PRODUCT NOTICE

SATELLITE XT

Product Updates for Compliance to EN 50270:2015

Previous black plastic connector design linking the Satellite XT (right) to the Extractive module (left).

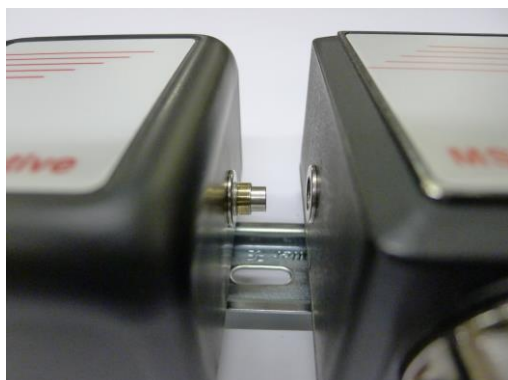
In order to meet the requirements of the latest European EMC standard, EN 50270:2015, certain aspects of the Satellite XT have been updated. These include a change in the enclosure material of the MST Extractive module and the use of a different style of connector that link the Satellite XT transmitters together with the Extractive and Pyrolyzer modules.

As of 1st December 2018, Honeywell will be supplying the revised designs of these products into the European market, featuring the updated connectors. In the case of the Extractive module the housing material will be aluminum instead of plastic. All of these updated models will be sold under a set of new part numbers, which are shown in the table below. Please use these part numbers when ordering Satellite XT products:

The images below show the previous and replacement units' connector designs. Use these to aid the identification of the different connectors used on these products.

Replacement plated metal connector design linking the Satellite XT (right) to the Extractive module (left).
